From: Pederson Ronda M (AREVA NP INC) [Ronda.Pederson@areva.com]
Sent: Friday, March 27, 2009 3:40 PM
To: Getachew Tesfaye
Cc: DELANO Karen V (AREVA NP INC); BENNETT Kathy A (OFR) (AREVA NP INC); NOXON David B (AREVA NP INC); WELLS Russell D (AREVA NP INC)
Subject: Response to U.S. EPR Design Certification Application RAI No. 183, Supplement 1
Attachments: RAI 183 Supplement 1 Response US EPR DC.pdf

Request for Additional Information No. 183 (1464), Supplement 1, Revision 0

U. S. EPR Standard Design Certification

SRP Section: 08.03.01 - AC Power Systems (Onsite)

Figure 08.03.01-22-01—EUPS Panelboard Single Line Drawing Sample

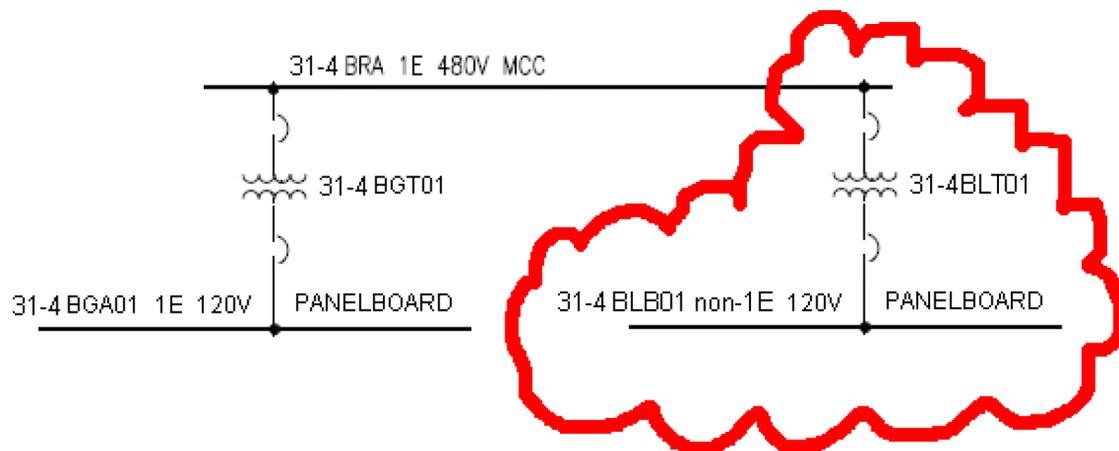
FSAR Page 8.3-41 discusses 120 Vac uninterruptible single phase power supplies (31 through 34 BGA01) and overcurrent protection for safety related and selected non-safety-related loads. Provide a sample of panel board drawings for 120 Vac UPS single power supplies and elaborate how those overcurrent protection systems for safety related and selected non-safety-related loads are designed.

The U.S. EPR FSAR will be revised to add Class 1E Uninterruptible Power Supply (EUPS) 120 Vac panelboards for non-safety-related loads. The additional panelboards supply only the selected non-safety-related EUPS 120 Vac loads, while the existing panelboards supply only safety-related loads. U.S. EPR FSAR, Tier 2, Section 8.3.2.1.1.7 will be changed to add: "Panelboards 31BLB01, 32BLB01, 33BLB01, and 34BLB01 provide a 120 Vac uninterruptible single phase power supply and overcurrent protection for the selected 120 Vac non-safety-related EUPS loads," and "Isolation of the non-safety-related loads from the EUPS is described in Section 8.3.1.1.9."

The configuration of the additional panelboards for non-safety-related loads, in relation to the existing panelboards, is shown in Figure 08.03.01-22-1—EUPS Panelboard Single Line Drawing Sample. The safety-related EUPS motor control center (MCC) (31 through 34 BRA) supplies the non-safety-related transformer (31 through 34 BLT01) of the respective division. The non-safety-related transformer (31 through 34 BLT01) provides 120 Vac to the non-safety-related panelboards (31 through 34 BLB01) of the respective division.

The Class 1E circuit breaker located on 31 through 34 BRA MCC provides isolation from the non-safety-related transformer (31 through 34 BLT01) and non-safety-related loads. The circuit breaker is a qualified isolation device in accordance with IEEE Standard 384-1992 (Reference 1) and meets the regulatory guidance of RG 1.75.
